CHAMPLAIN MEMORIAL in Honor of the 98 Lives Lost or **A NICER FRONT ENTRANCE FOR DAMAC?**

SURFSIDE MAYOR AND COMMISSIONERS, **WE RESPECTFULLY ASK YOU THAT...**

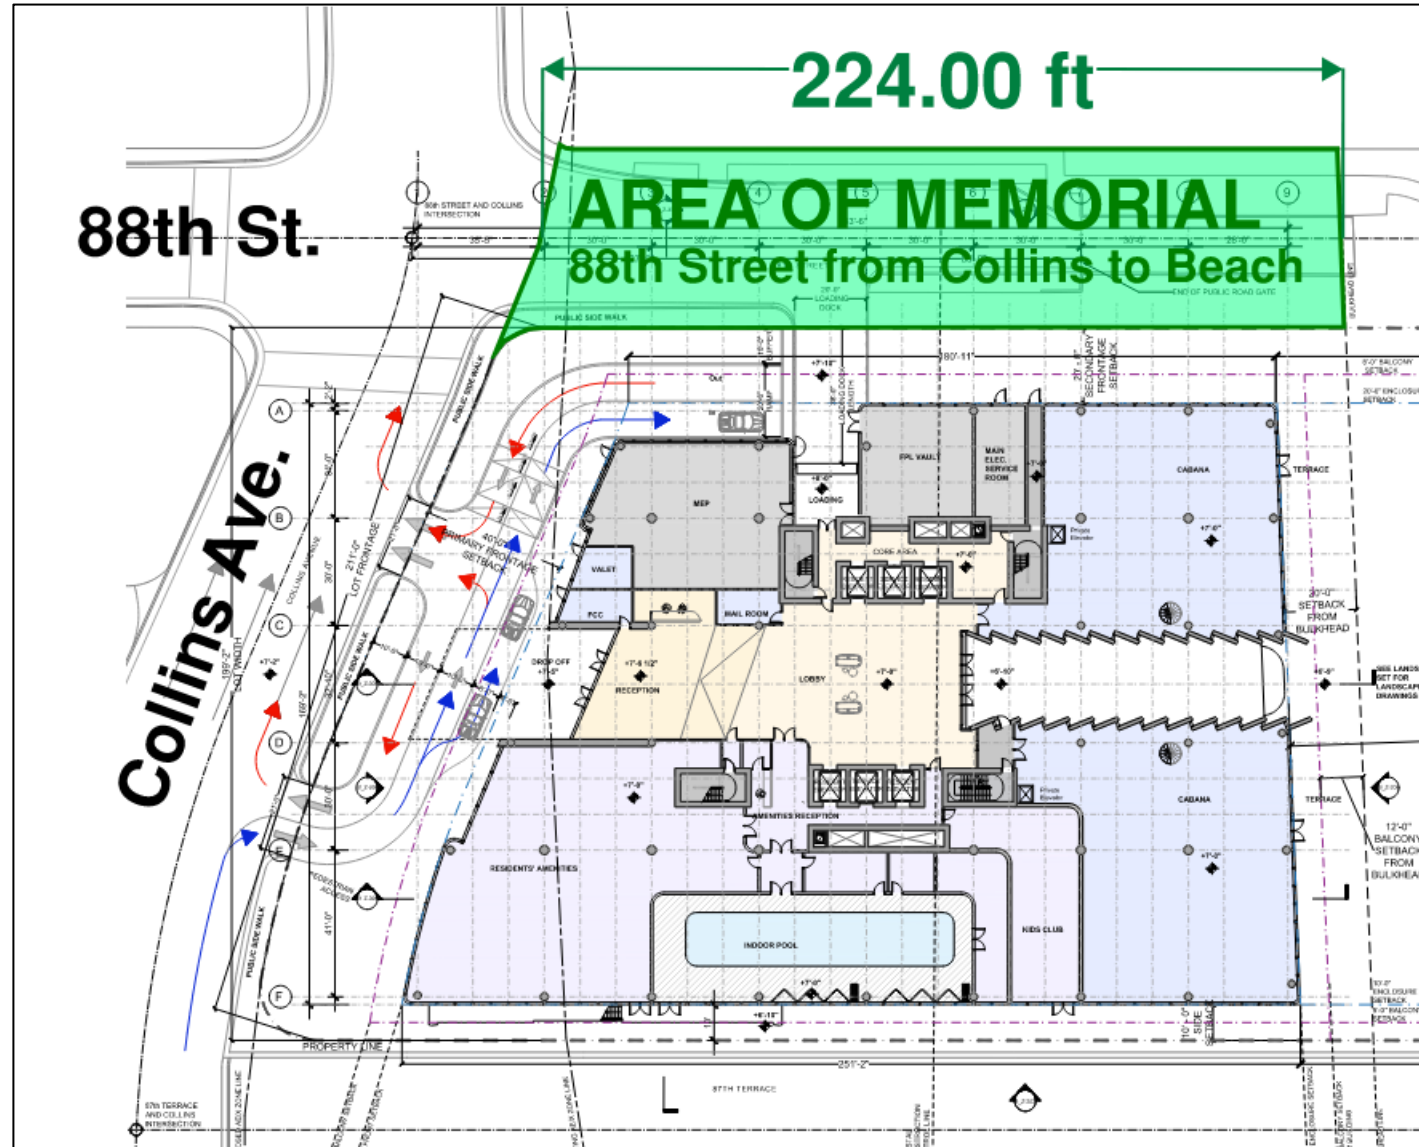
THIS IS THE AREA DESIGNATED FOR THE CHAMPLAIN MEMORIAL

The entire 88th Street from Collins to the Beach

THIS IS THE AREA OF THE CHAMPLAIN MEMORIAL THAT WILL BE TAKEN BY DAMAC (or given by Surfside?) FOR THEIR LOADING DOCK AND TRASH COLLECTION IF THE CURRENT SITE PLAN IS APPROVED

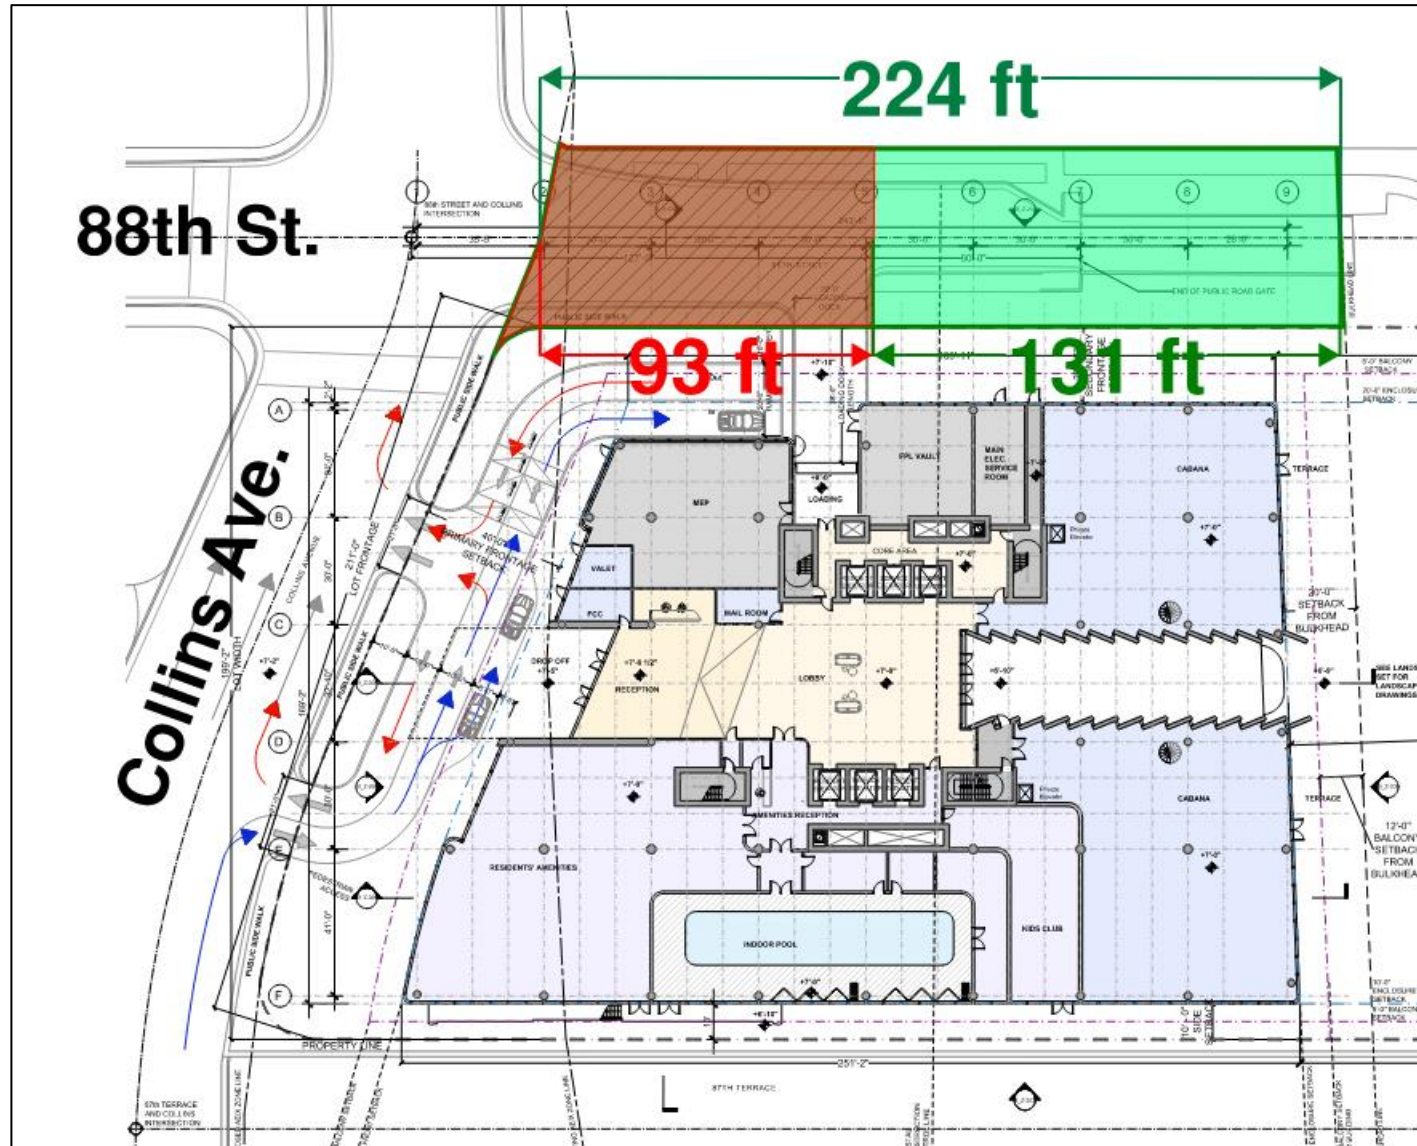
41.5%
OF THE AREA
DESIGNATED
FOR THE
MEMORIAL
WILL BE LOST

FOR WHAT?

SO DAMAC CAN HAVE A PRETTY FRONTAGE AND VALET ENTRANCE ???

THAT IS WHY DAMAC MADE US BELIEVE (*UNDER OATH*)
THAT FDOT “MADE THEM HAVE THE LOADING DOCK ON 88TH STREET”

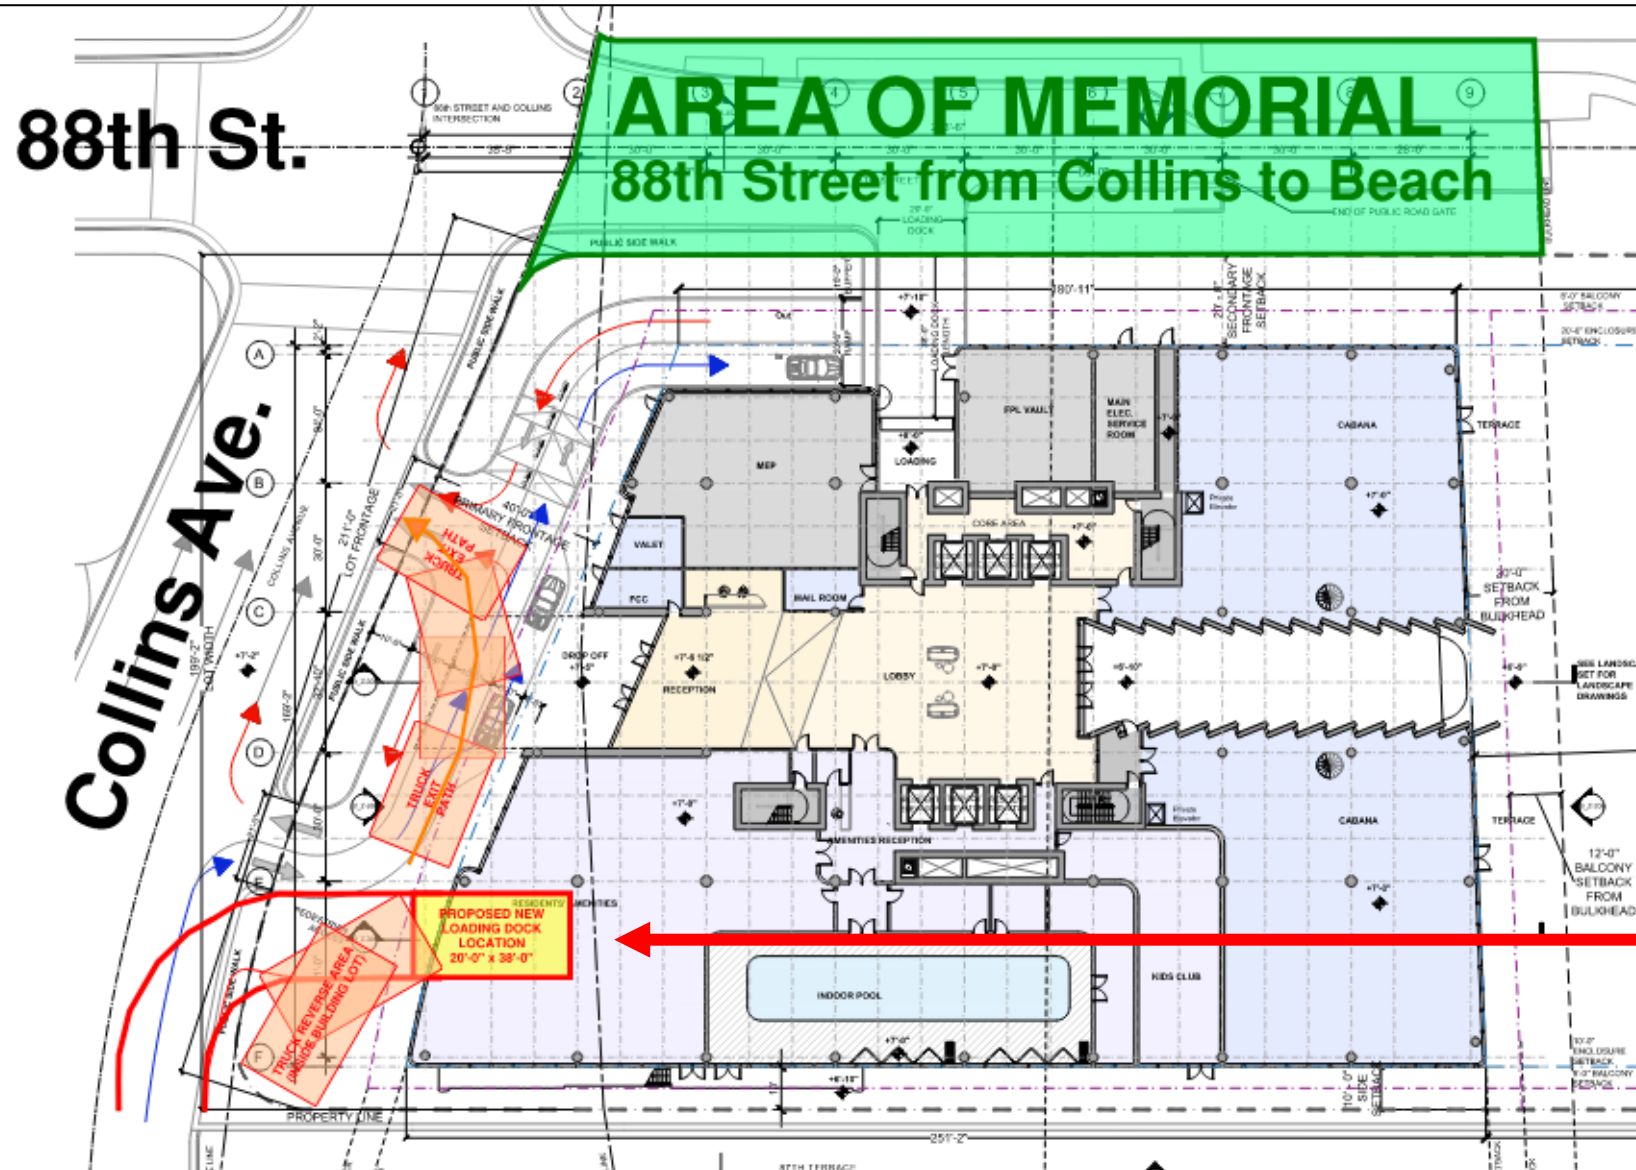
SURFSIDE SHOULD TELL THE DEVELOPER THAT **THE MEMORIAL SITE IS NOT A STREET. THEY HAVE TO GO BACK TO THE DRAWING BOARDS AND MOVE THEIR LOADING DOCK AWAY FROM THE MEMORIAL SITE.**

THERE ARE MANY OPTIONS WITH LOADING DOCK & GARBAGE COLLECTION THROUGH COLLINS AVE, THAT STILL MEET FDOT REQUIREMENTS...

MOST BUILDING ON COLLINS DON'T HAVE A SIDE STREET, AND STILL COMPLY WITH FDOT REQUIREMENTS.

THIS ON THE LEFT SIDE IS JUST ONE OPTION.
